FAUNTLEROY WAY APARTMENTS | DESIGN RECOMMENDATION

April 6, 2017

RESPONSES TO EARLY DESIGN GUIDANCE

SUMMARY OF EDG BOARD RECOMMENDATIONS

EXTERIOR LIGHTING PLAN

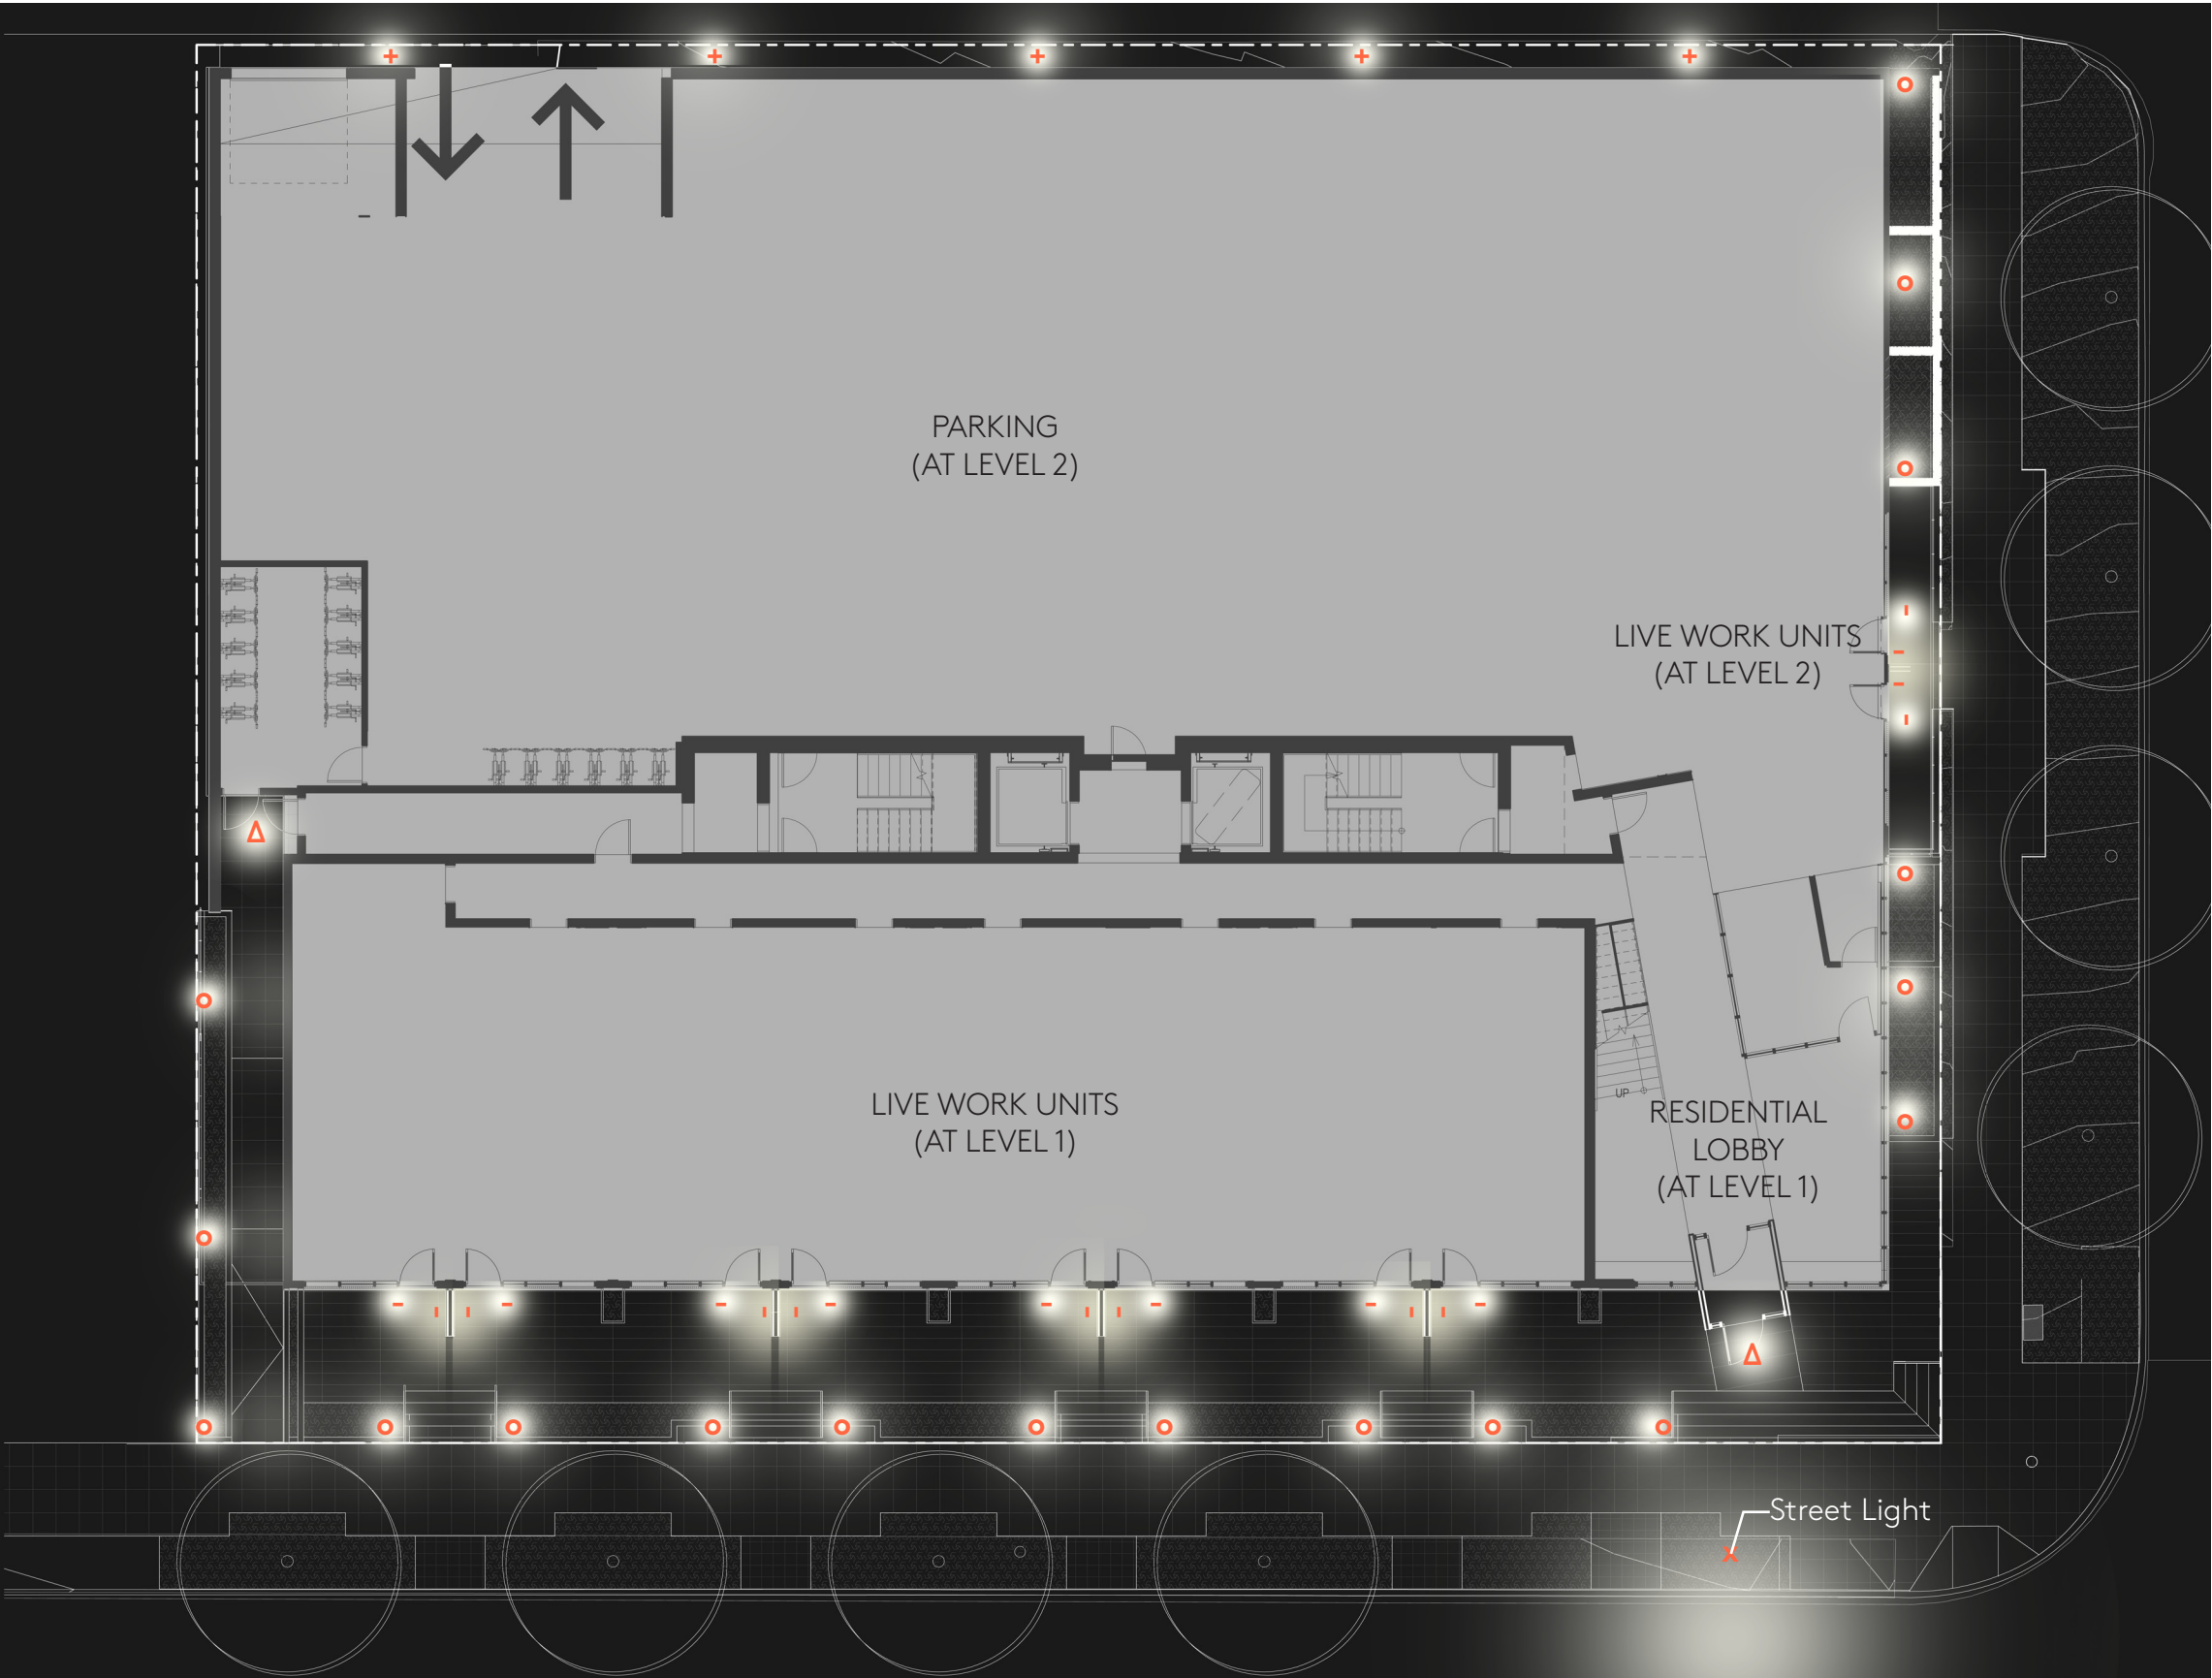
3f. For the next meeting, the applicant should provide additional details on lighting, specifically looking at illumination of the street-level setback along Fauntleroy.

BICYCLE STORAGE

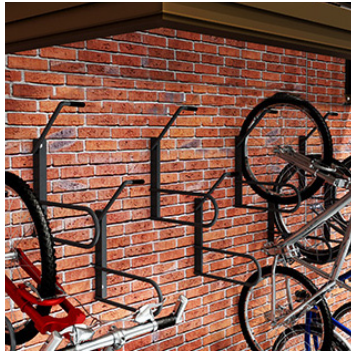
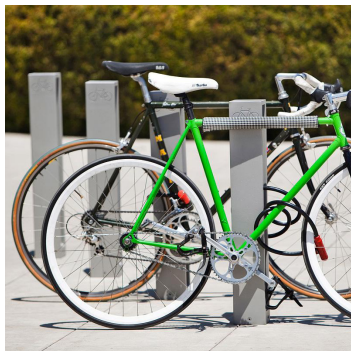
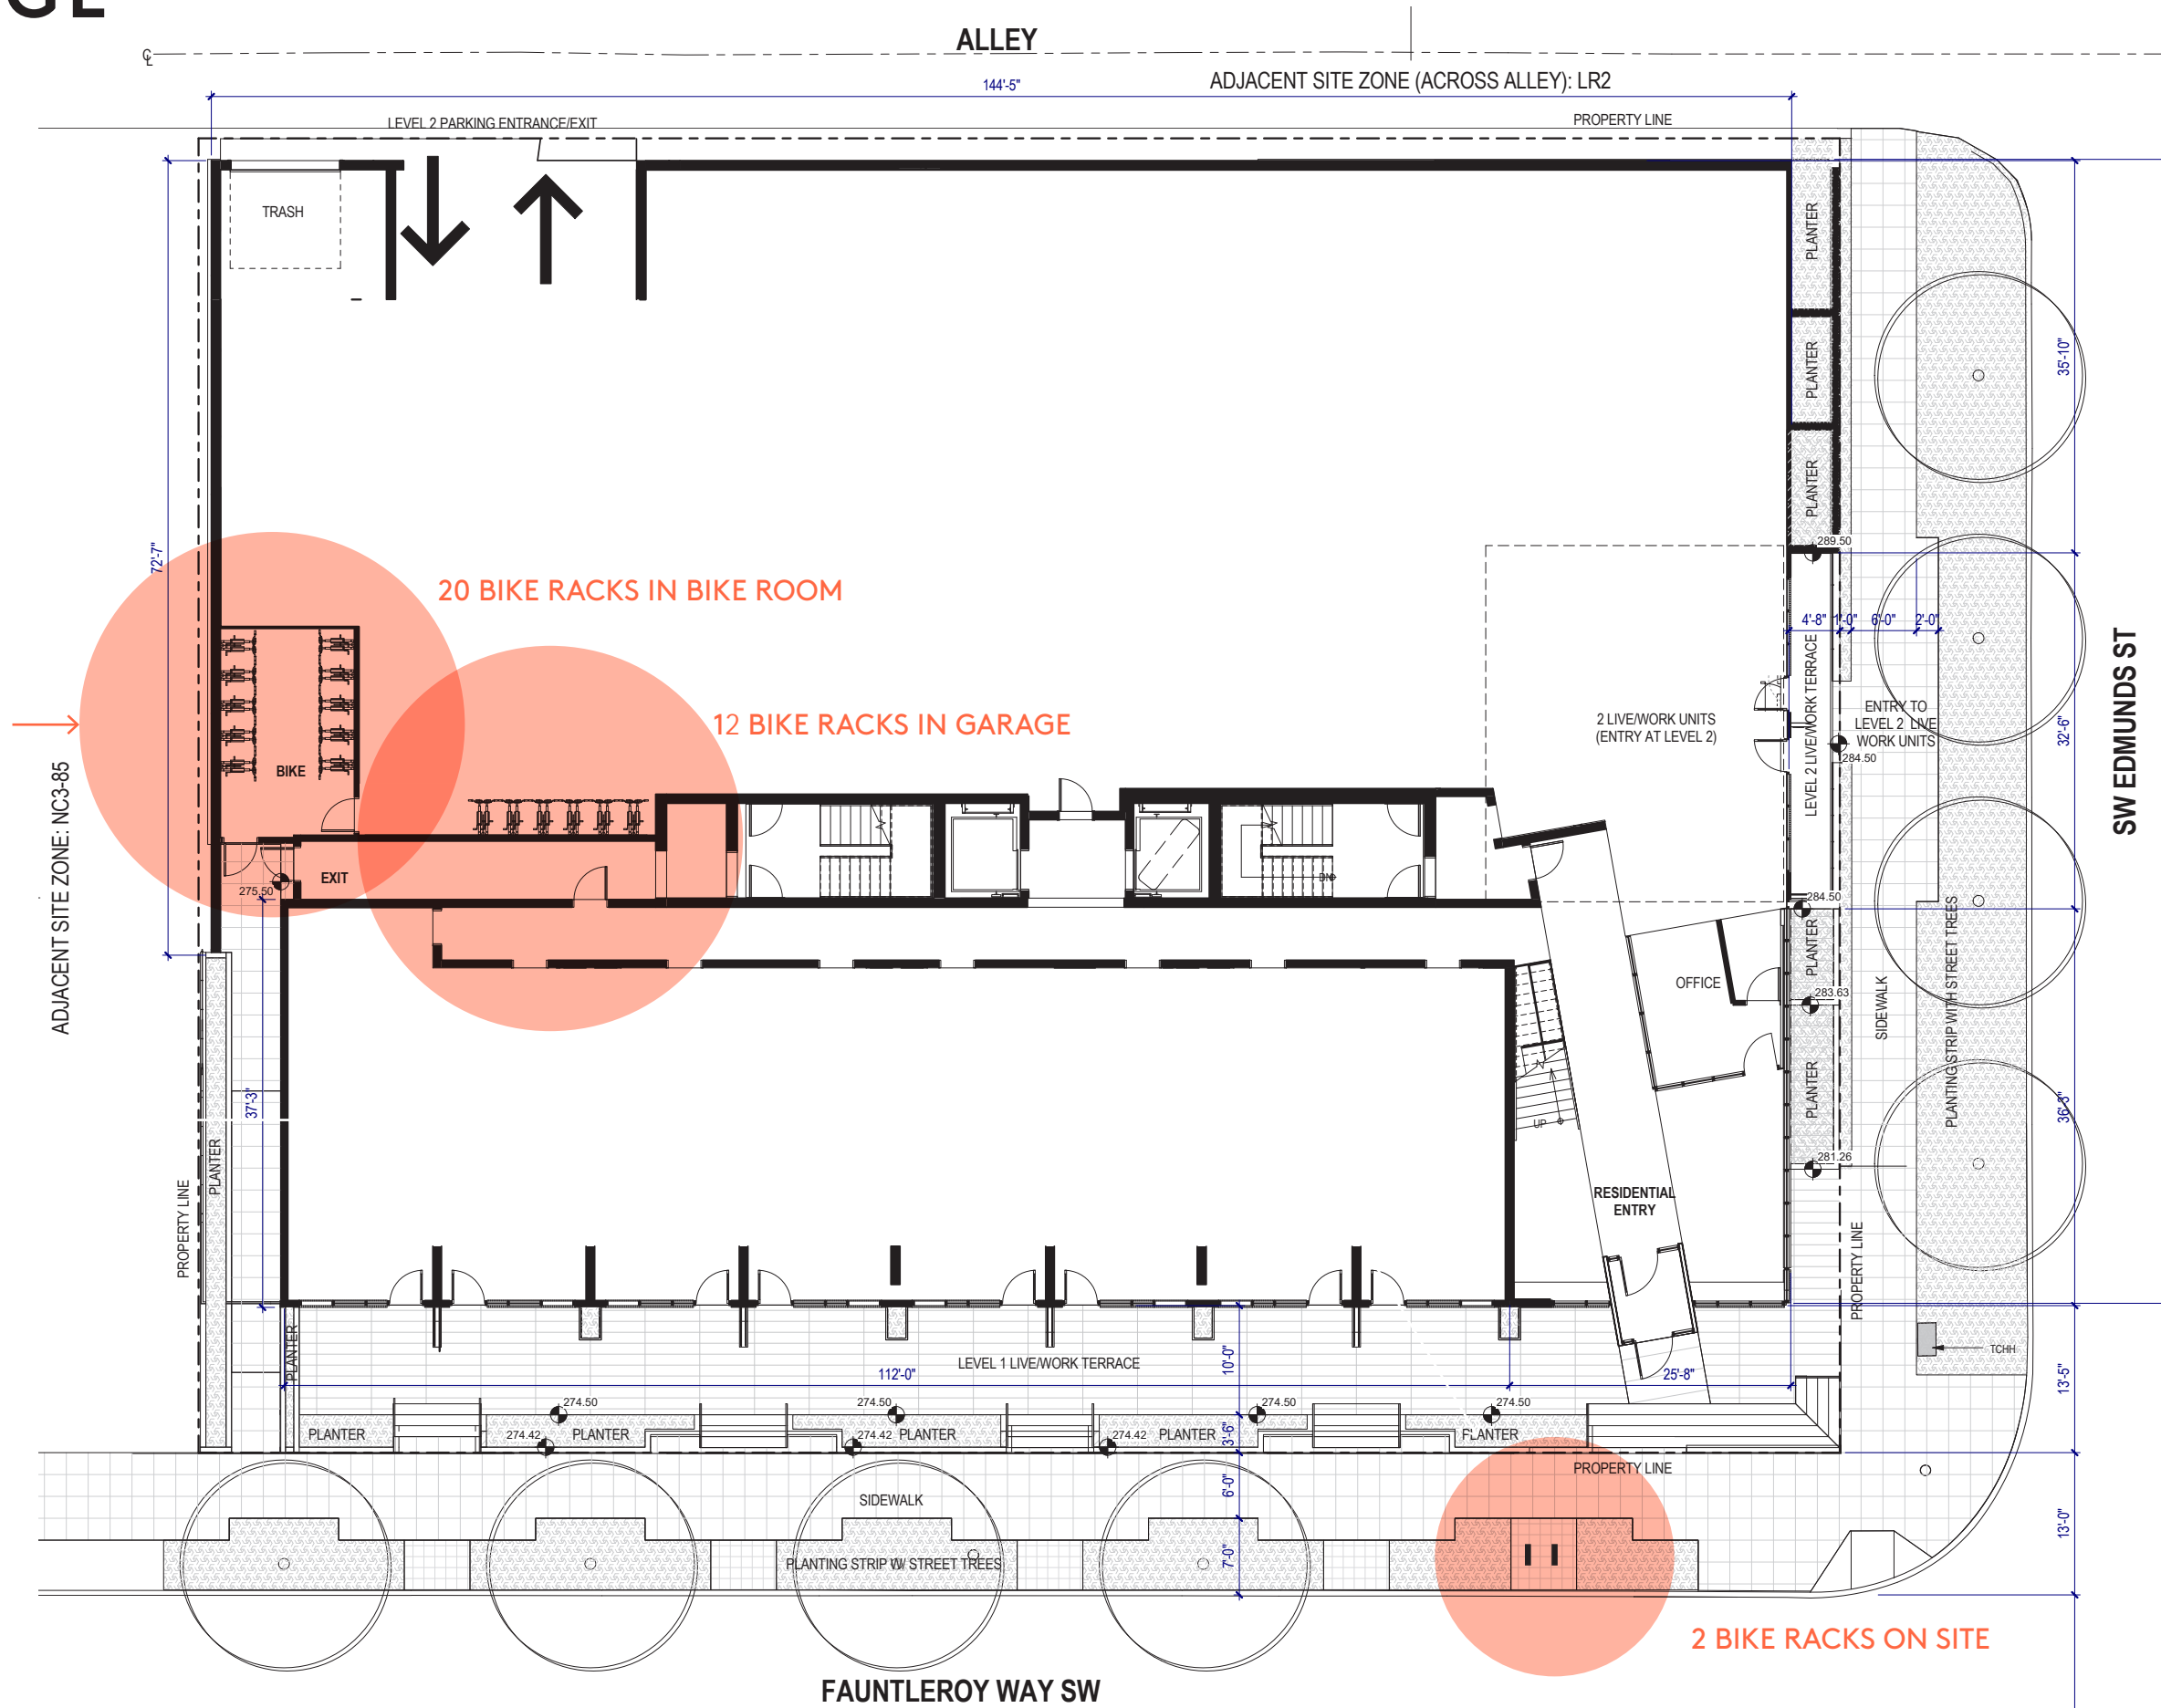
3d. Provide additional information on the bicycle storage and consider how the future lightrail should influence the project design.
